**Appendix 10:
Clarification Note
Blasting Methodology and
Mitigation**

Aberdeen Harbour Expansion Project

Clarification Note: Blasting methodology and mitigation

Aberdeen Harbour Expansion Project
Response to Marine Scotland Science
Clarification of underwater noise issues

Figure 1: Underwater blast levels from a confined detonation with varying degrees of bubble curtain attenuation in place

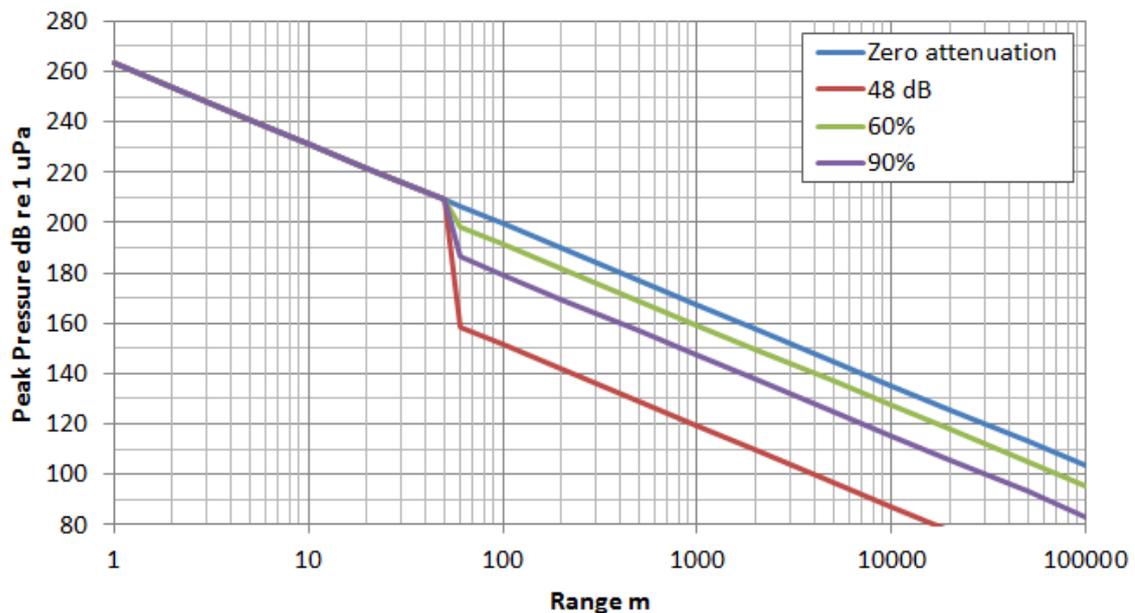
Scottish Natural Heritage (SNH) has raised concerns that the estimated sound level of 262 dB from a single buried charge is capable of causing auditory damage to cetaceans at a distance of approximately 820 m.

SNH has raised concerns about the possibility that multiple waveforms from multiple charges will result in constructive and destructive interactions, which may affect the amplitude of the blast wave. No data is available in the literature to quantify the effects of multiple blasts. However, the initial rise of pressure from a single detonation is of the order of microseconds, whilst the detonations will occur at intervals of the order of 25 milliseconds. This means that the initial rise in pressure will have decayed before the next rise comes along. The effect of constructive interference from successive blasts is, therefore, considered to be small.

Figure 1 shows the blast level from a confined detonation both with and without a bubble curtain in place. The amount of attenuation applied to the 'no bubble curtain' baseline is, variously, 48 dB, 60% reduction and 90% reduction in peak levels.

If the 170 dB threshold is used as a metric, it can be seen in Figure 1 that the noise level falls to 170 dB at a distance of 830 m when there is no curtain in place. With a curtain in place and producing an attenuation of 60%, the 170 dB threshold is attained at a distance of approximately 420 m, while the distance falls to 200 m if the curtain has a 90% attenuation. If a 48 dB reduction in blast levels is applied, the critical threshold is attained at a distance of 58 m.
